Old Richardson Highway Intersection Improvements

Diagnostic Team Report

October 2019

Prepared For:
Alaska Department of
Transportation and Public
Facilities Northern Region

Figure 4: 5th Avenue Crossing Sight Distance Triangle

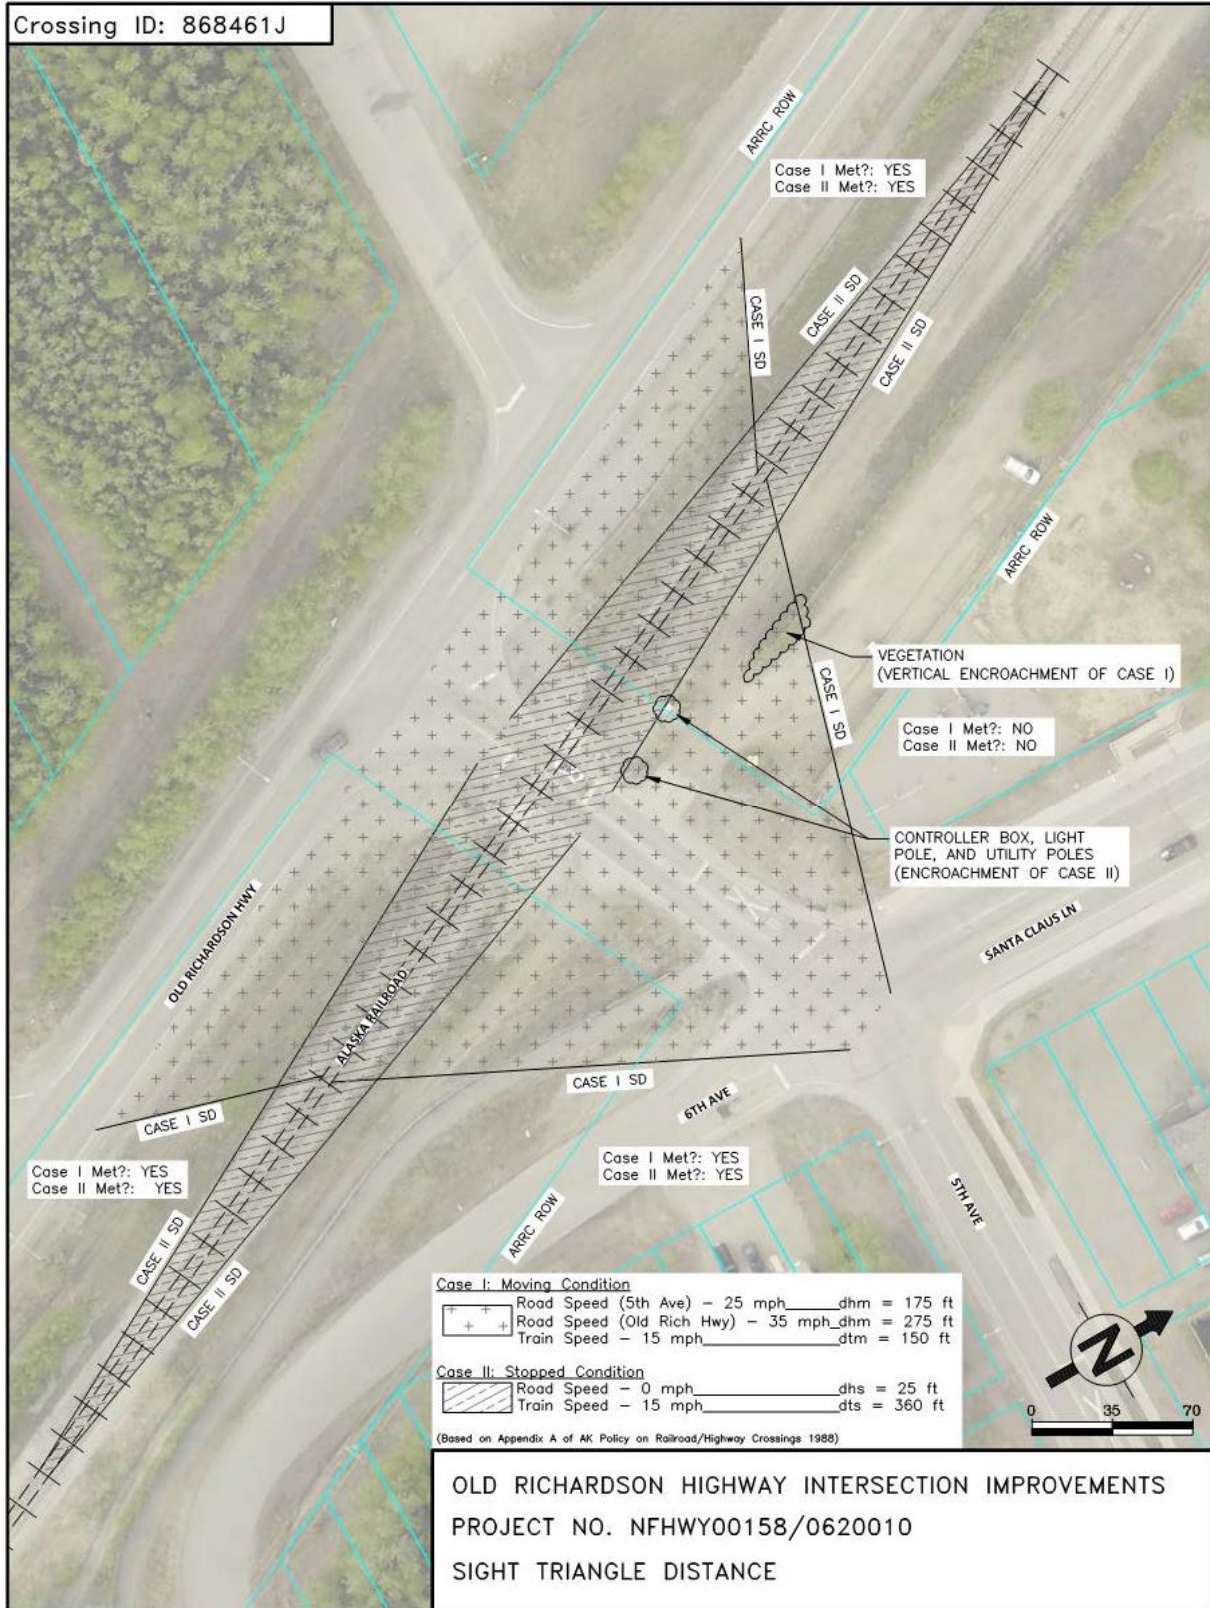
Figure 4 lays out the sight distance requirements for both cases for the 5th Avenue crossing. There is inadequate sight distance for both cases for eastbound traffic looking north along the tracks. For Case I, existing vegetation encroaches into the sight triangle. This could be remedied by removing the vegetation and underlying organic layer to prevent regrowth. For Case II, a group of utility poles, a light pole, and a signal controller box encroach into the sight triangle. These items should be relocated outside of the sight triangle.

Figure 5: 8th Avenue Crossing Sight Distance Triangle

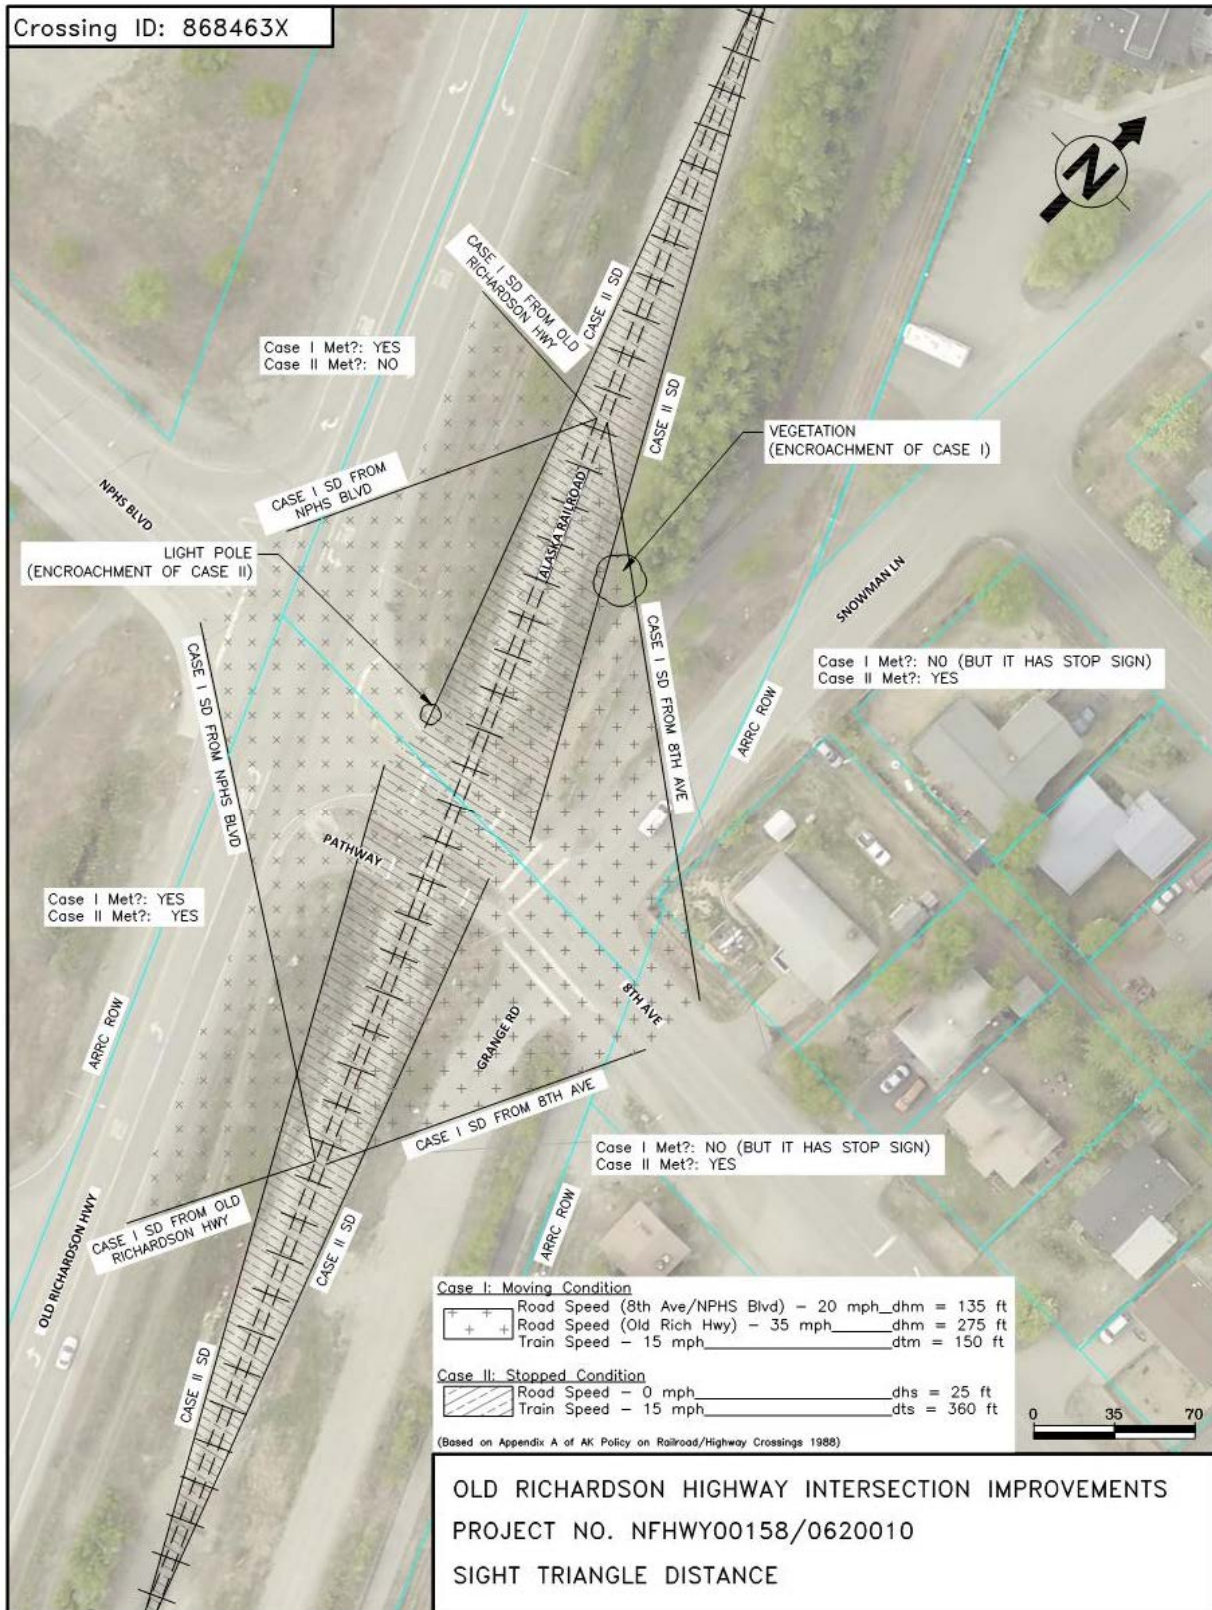
Figure 5 illustrates the sight distance requirements for both scenarios for the 8th Avenue crossing. Case I is not met for the eastbound traffic looking north at the tracks due to vegetation encroachment. Since the eastbound traffic is stop-controlled at the crossing, Case I sight distance does not have to be met. However, Case I sight distance triangles should be met whenever possible. Removing the vegetation, include the underlaying organic layer, would resolve the issue. There is a light pole in the Case II sight triangle for the westbound traffic looking north at the tracks. This light pole is not grouped with other view encroachments and could be seen around by adjusting one's body position in the vehicle; therefore, it does not constitute an obstruction.

Figure 8: 5th Avenue Crossing Existing Traffic Control Devices

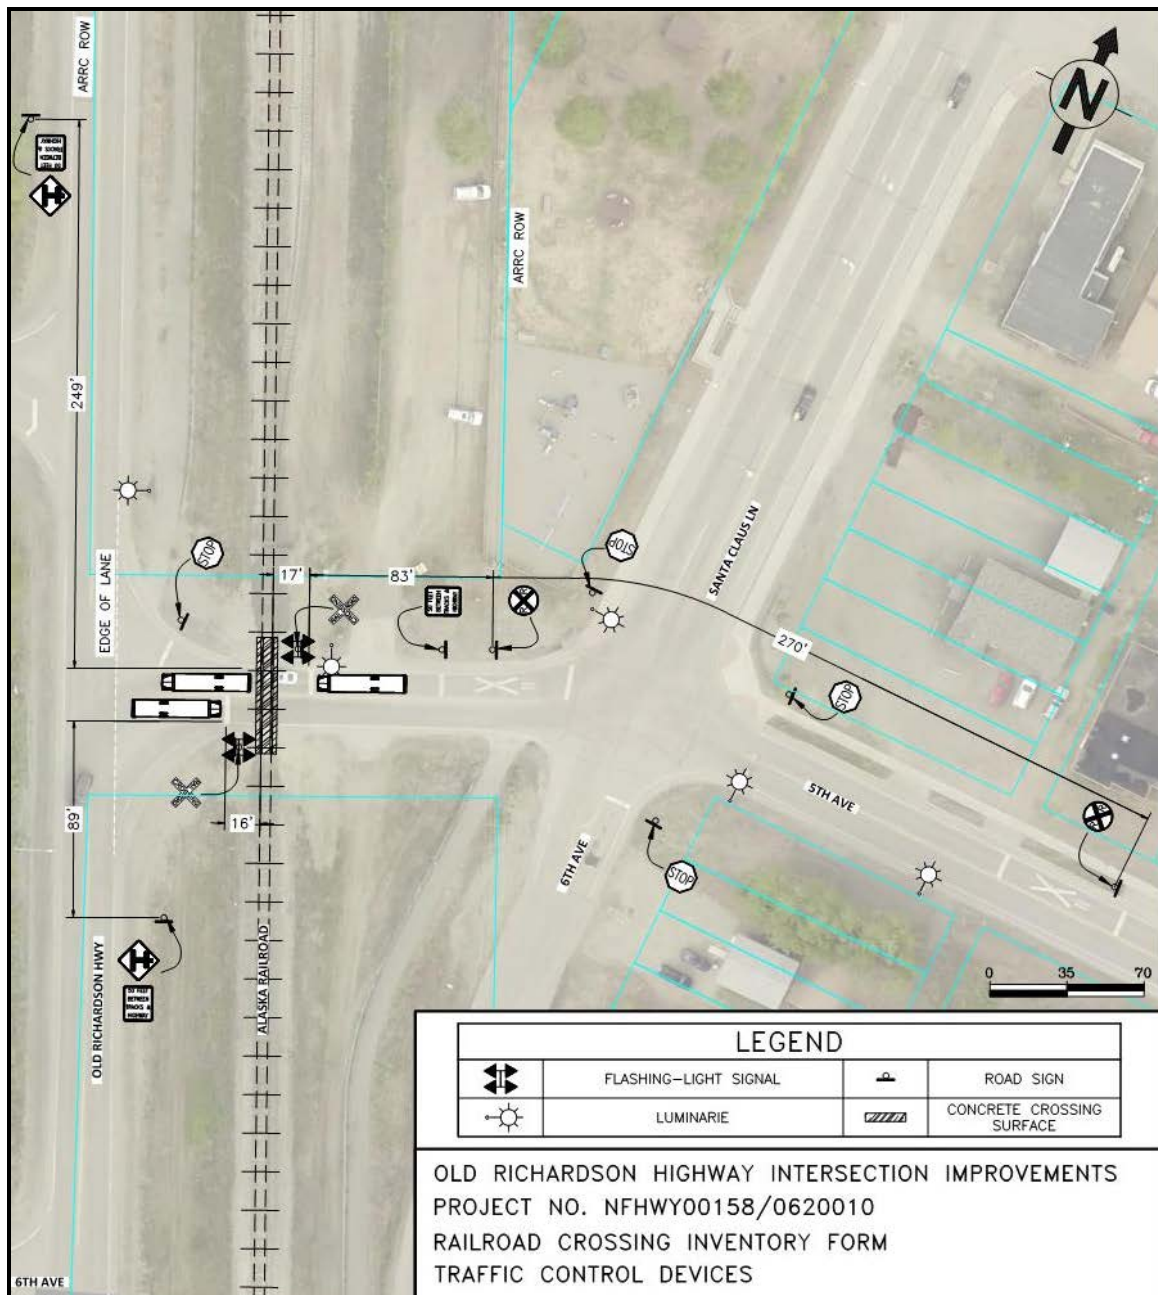
Figure 8 represents the existing traffic control devices at the 5th Avenue crossing. The crossing contains active traffic control devices in the form of flashing lights. Per the MUTCD, the existing stop bars and signs are appropriately located. Note that the advanced warning sign for the northbound approach on the Old Richardson Highway is located short of the minimum advanced placement distance (100 feet) per Table 2C-4 of the MUTCD. However, it is positioned to capture traffic turning north from 6th Avenue, and did not pose a concern for the DT.

Figure 11: 5th Avenue Crossing Existing Vehicle Storage

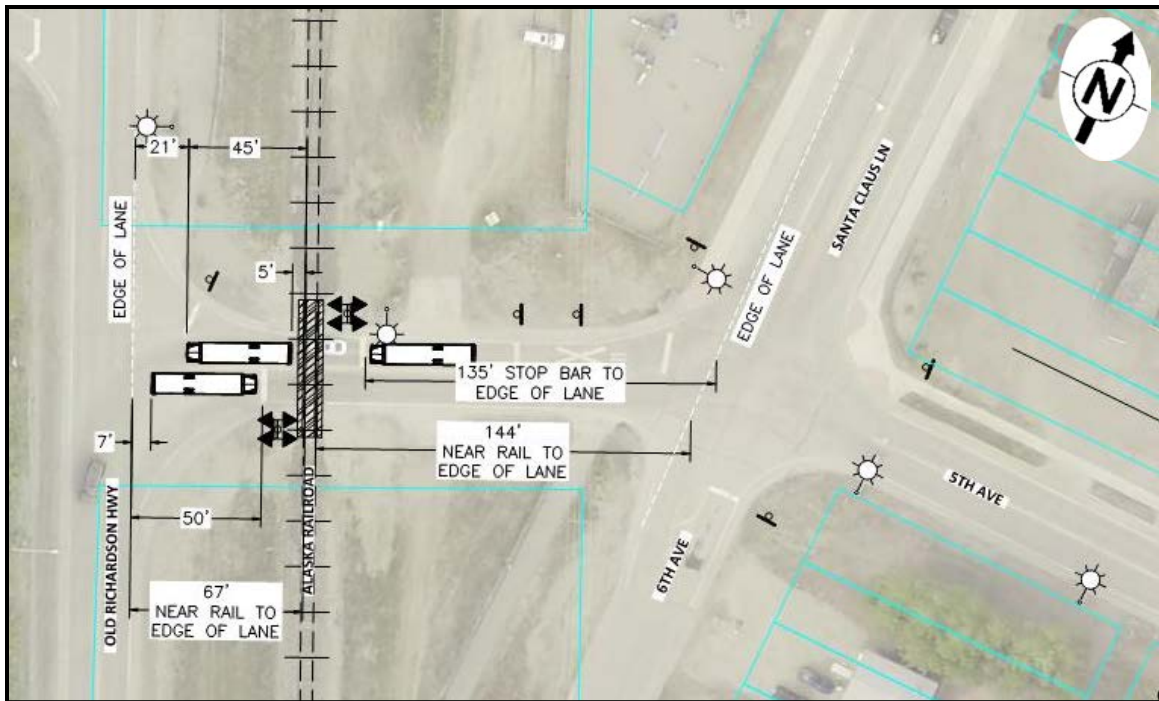
Figure 11 illustrates the existing vehicle storage at the 5th Avenue crossing. This crossing has sufficient storage space for a school bus. Though, as it is currently placed, the stop bar on 5th Avenue at Old Richardson Highway prevents a westbound stopped bus from clearing the dynamic envelope of the train. However, there is enough distance to the edge of lane on Old Richardson Highway to relocate the stop bar up to 11 feet closer to the highway, thus providing more than enough space for the stopped bus to clear the dynamic envelope.

Figure 12: 8th Avenue Crossing Existing Vehicle Storage

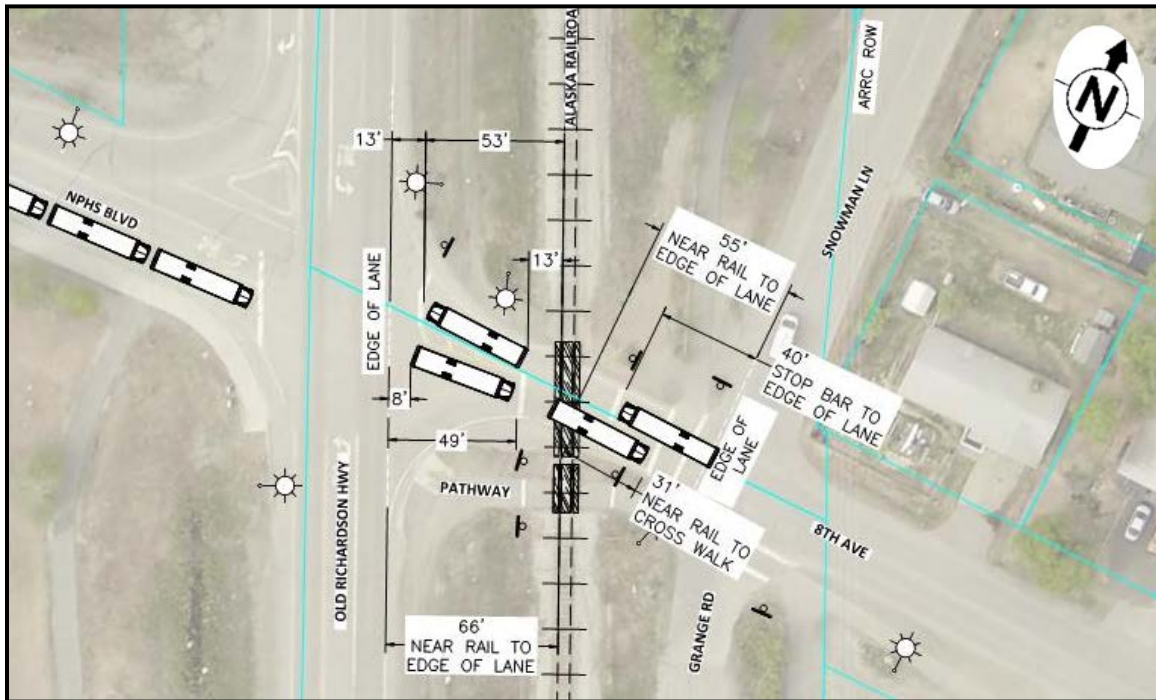
Figure 12 depicts the existing vehicle storage at the 8th Avenue crossing. This crossing has adequate storage space for a school bus on the west side of the tracks. The 8th Avenue-Snowman Lane/Grange Road intersection on the east side of the tracks limits the space available for vehicle storage. The eastbound traffic through the crossing is not required to stop at the intersection except in the case a pedestrian is using the cross walk. In this situation, the school bus would completely block the tracks. In addition, the existing available storage for westbound vehicles on 8th Avenue before the crossing falls short from the desired distance. A stopped bus would block the cross walk and slightly encroach into the travel lane of Snowman Lane. Relocating the cross walk outside the design vehicle storage area would help alleviate this issue.

Figure 13: 5th Avenue Alternative – Pedestrian Crossing

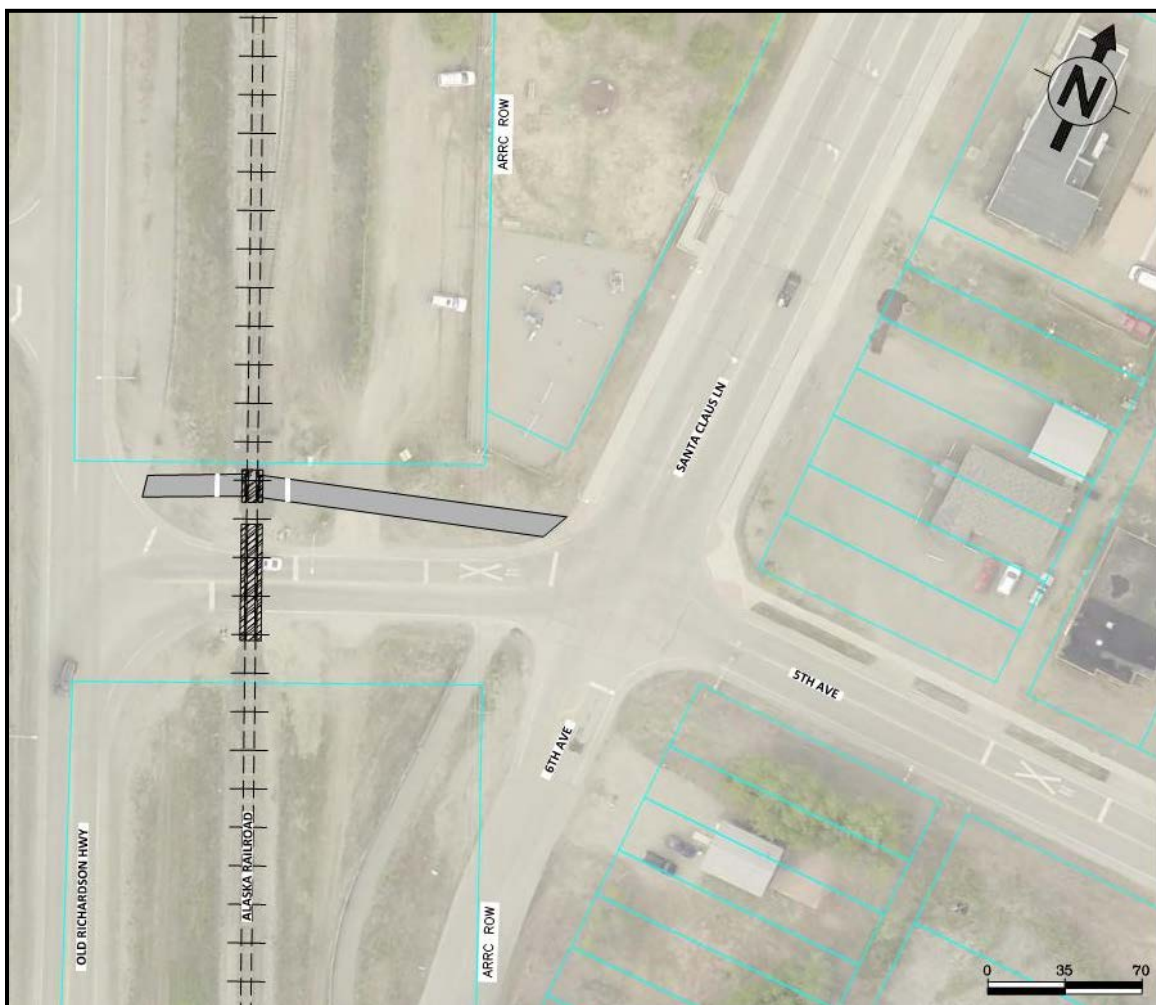
The design alternative for the 5th Avenue intersection involves constructing a pedestrian pathway on the north side of the crossing. This will increase the crossing width. The DT recommended to relocate the sight-encroaching light pole during the pathway construction. They also advised that the pathway crossing is required to have the same traffic control treatment as the adjacent roadway crossing. As noted earlier, one way to effectively meet this requirement is to construct an abutting sidewalk and control both the road and sidewalk by the same devices. In doing this, however, the existing flashing light signal and utility pole would require relocation, as they are currently within the footprint of an attached sidewalk. Figure 13 shows the pedestrian pathway alternative as presented at the DT meeting.

Alternative: Pedestrian Pathway		Pedestrian facilities at a railroad crossing are required to have the same traffic control as the adjacent road. Since flashing lights are present at the railroad-road grade crossing, flashing lights would also be required at the pathway. The most expedient way to accomplish this is to construct an abutting sidewalk, in which the road and pedestrian facility would share the traffic control.

Figure 14: 8th Avenue Alternative – Roundabout

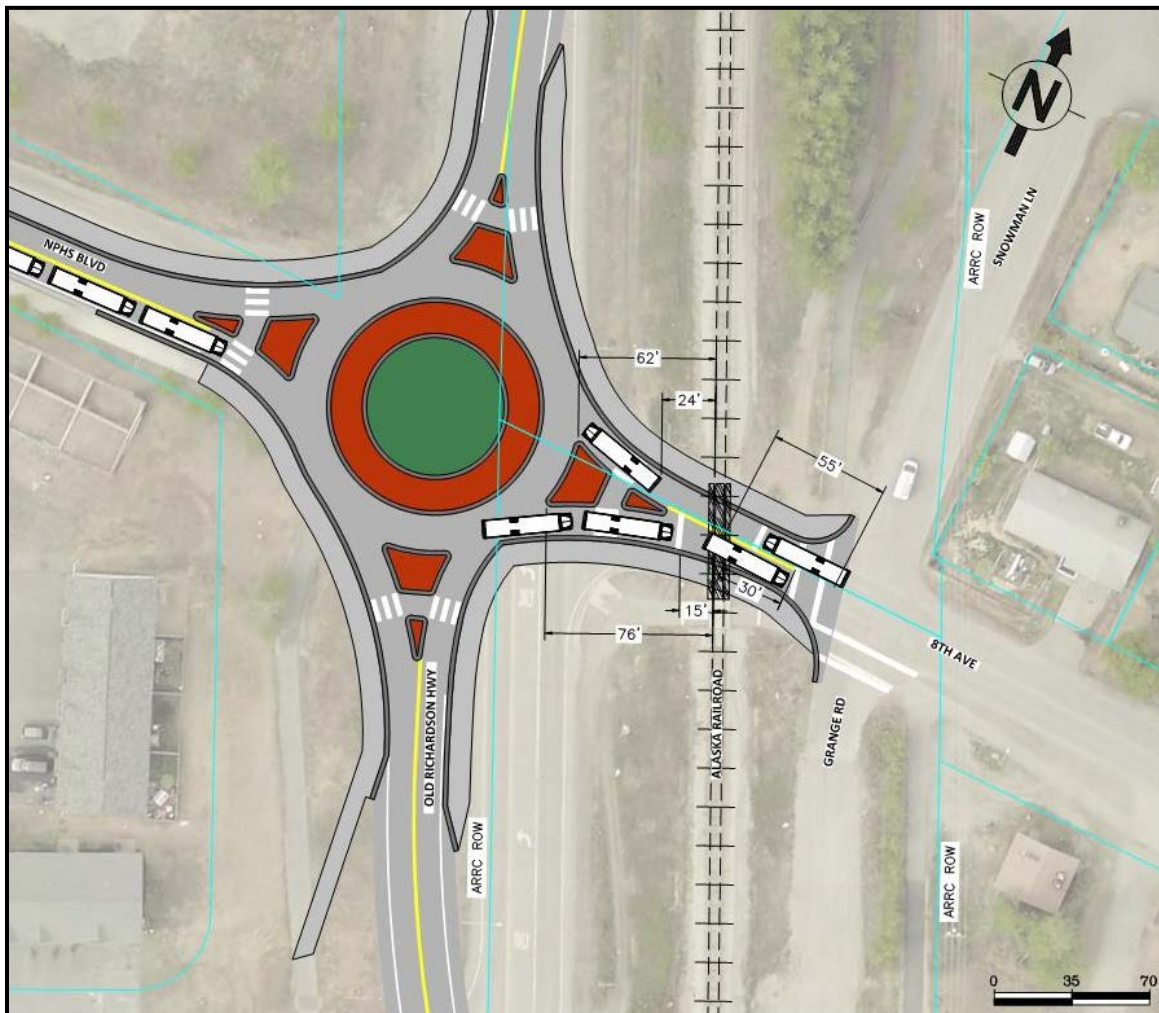
One design alternative for the 8th Avenue-Old Richardson Highway intersection is construction of a roundabout. Because of the proximity to the crossing, this alternative was determined to not be a viable option. The mandatory school bus safety stops, as well as stopped vehicles during the presence of a train, would result in traffic queuing into the roundabout, causing a grid-lock of all traffic at the intersection. In addition, westbound traffic queued at the roundabout would have no means to escape if it was stopped on the tracks when a train arrived. Figure 14 shows the roundabout alternative as presented during the DT meeting.

Alternative: Roundabout		In most cases, roundabouts near railroad-road crossings are not permitted.
